## Statewood Properties Ltd.

#### MEMORANDUM

ENGINEERING COMMENTS FOR APPLICATION RO100145 AT

9181, 9199. 9205, 9213, & 9217 Glover Road and 9226 & 9232 McBride Street

#### TLR 8 - LOCAL RESIDENTIAL ROADS

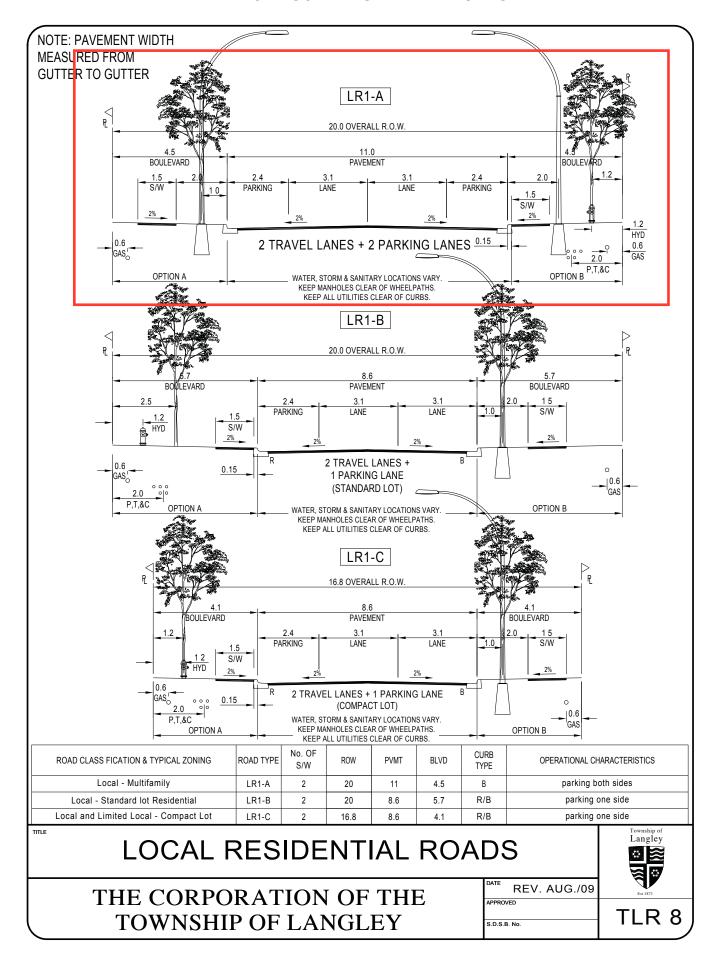
- The construction of the east half of McBride St. along the frontage of the property to Municipal Standard TLR8 / LR1-A (20.0 m ROW, 11.0 m asphalt).
- The construction of McBride Lane along the frontage of the property to Municipal Standard TLR8 / LR1-A (18.5 m ROW, 10.8 m asphalt).
